Generic Design Assessment – New Civil Reactor Build

Step 4 Structural Integrity Assessment of the EDF and AREVA UK EPR™ Reactor

Assessment Report: ONR-GDA-AR-11-027

14 November 2011

Figure 1: RPV Diagram from SDM RCS Part 3 (Ref. 128)

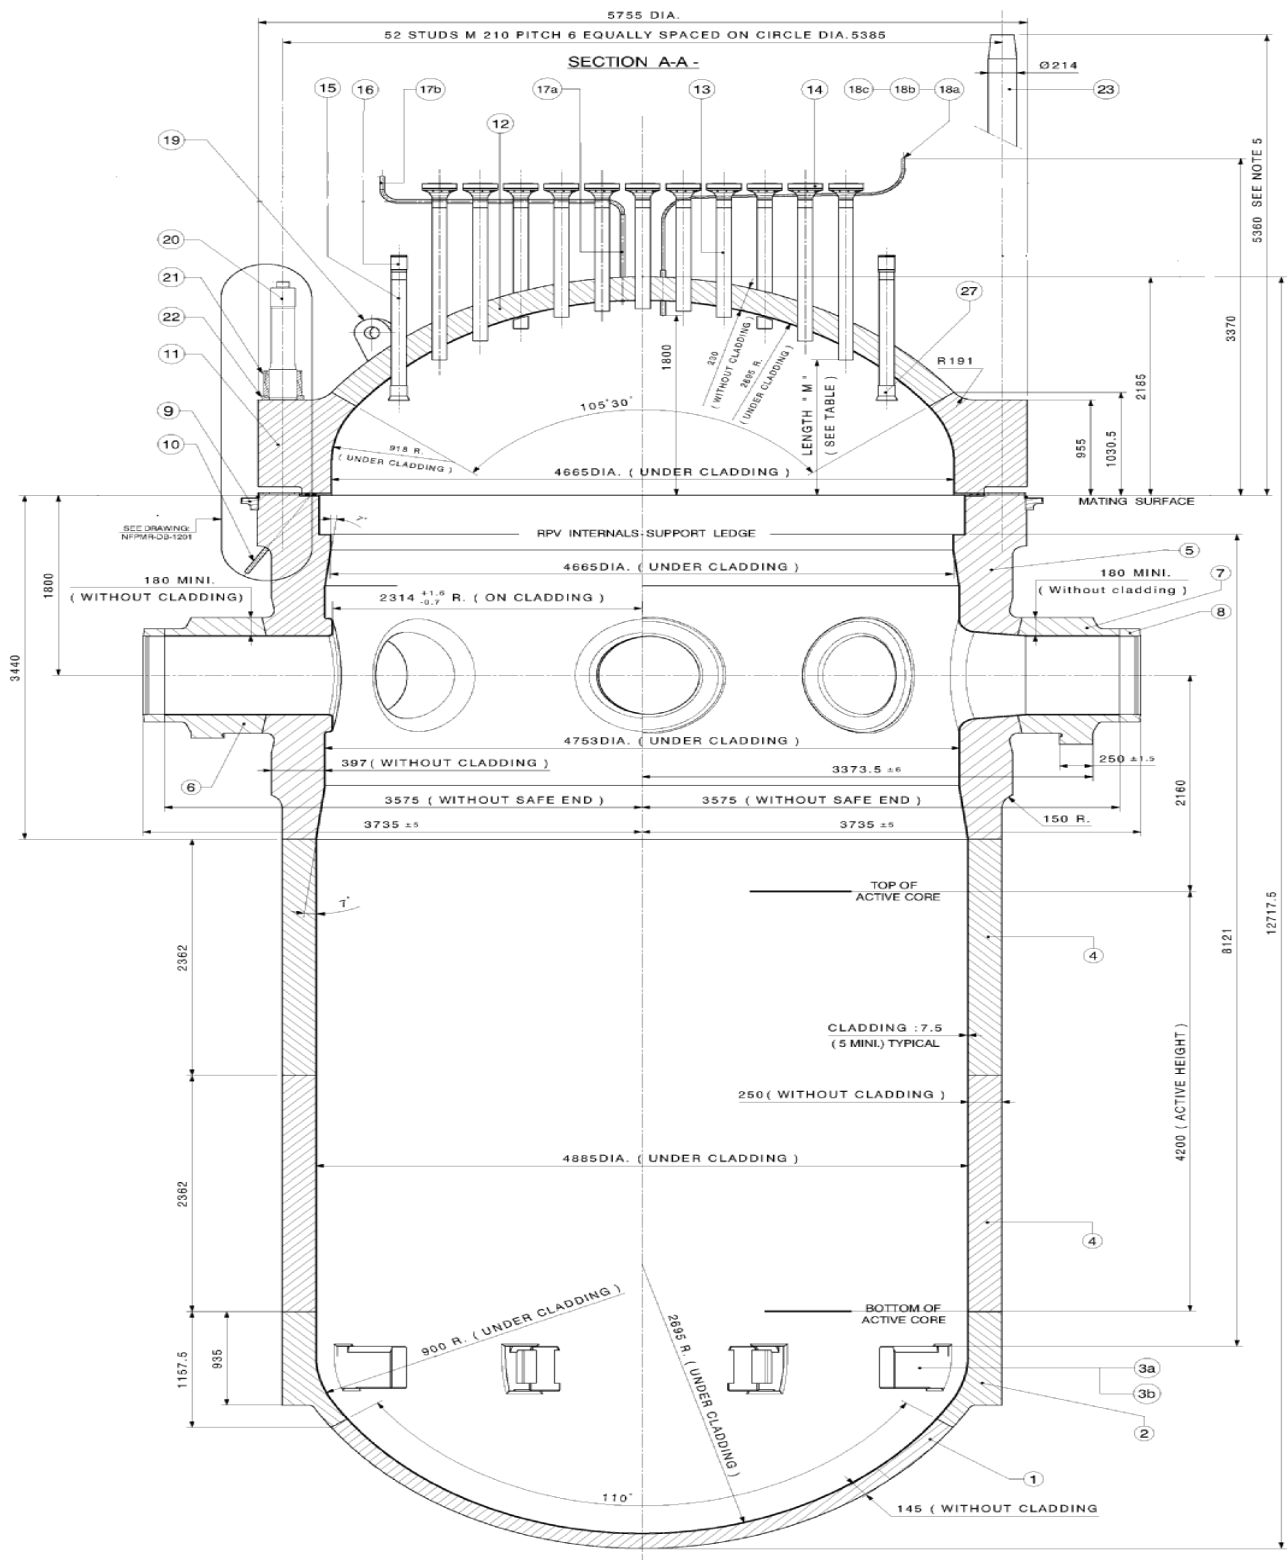
849 In September 2010, ultrasonic inspections revealed indications in some of the attachment welds between the adapter tubes for the control rod drive mechanisms (CRDM) and the instrumentation cabling. There are 89 CRDM tubes and 16 instrumentation tubes which are shown as items 13 and 15 in Figure 1.

Figure 2: EPR Mechanical Design Logic for Pressure Boundary Components (from PEER-F 10.0134/A)

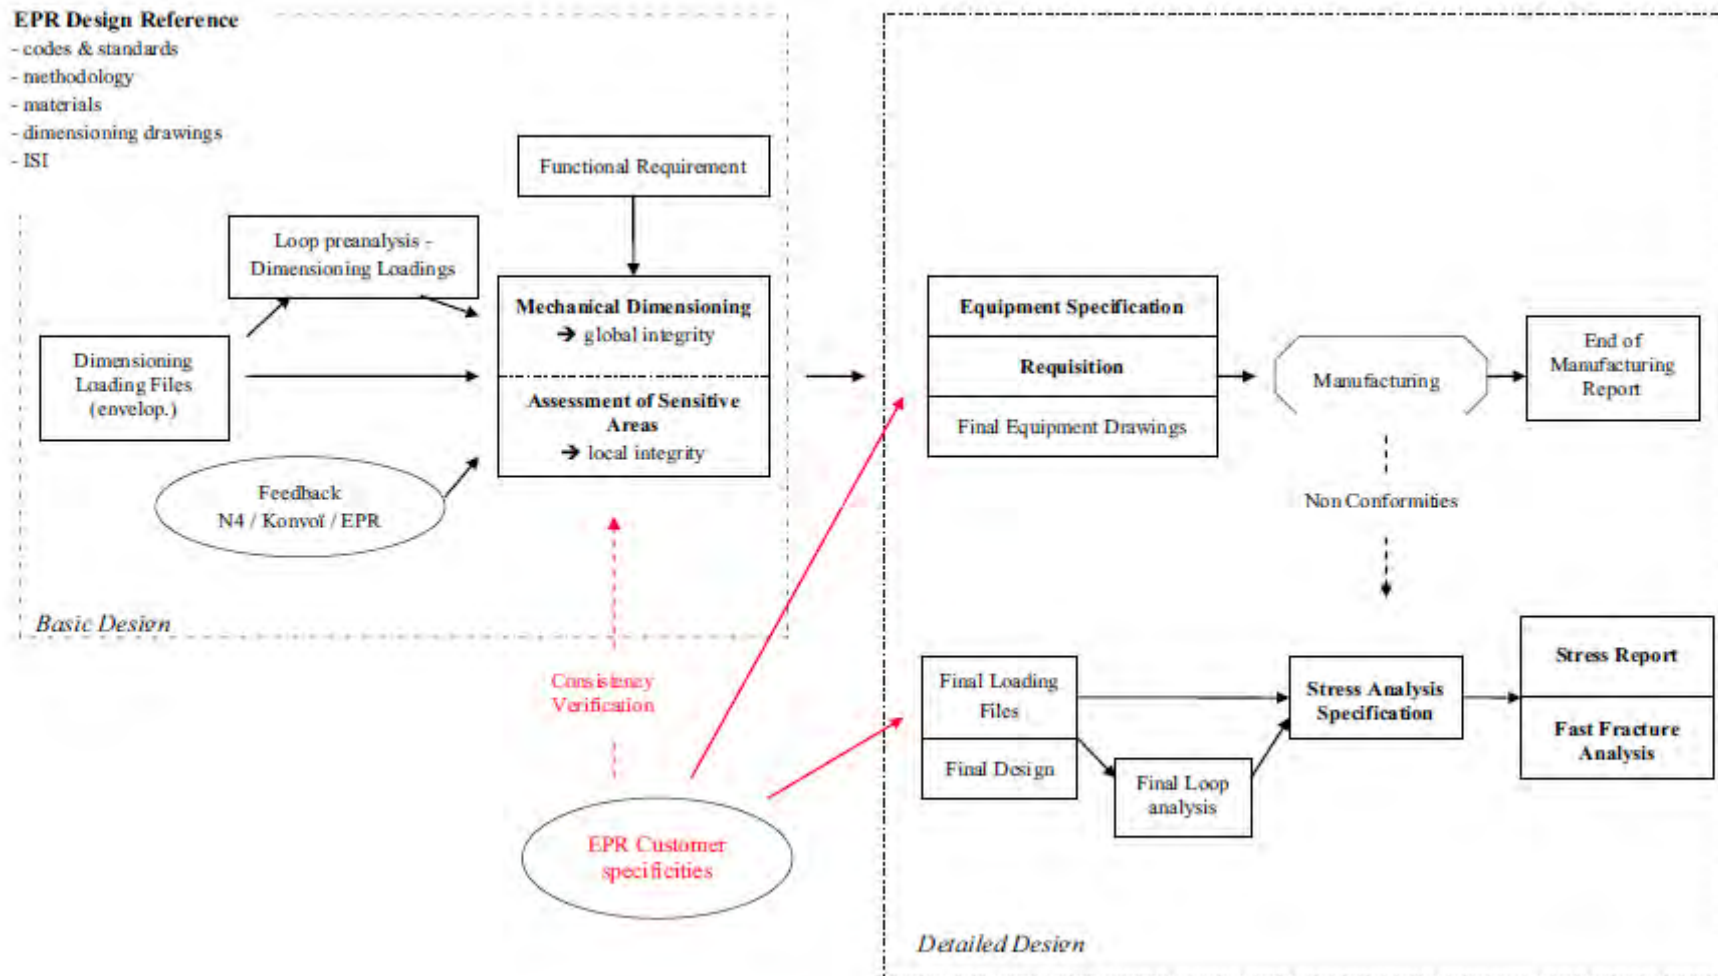
- 860 The final code based fatigue usage factor analysis for the pipework will only be undertaken during the project specific 'Detailed Design' phase, see Figure 2, but a fatigue usage factor analysis should have been completed on the primary circuit pipework during the 'Basic Design' phase, see Figure 2, using generic transient data.
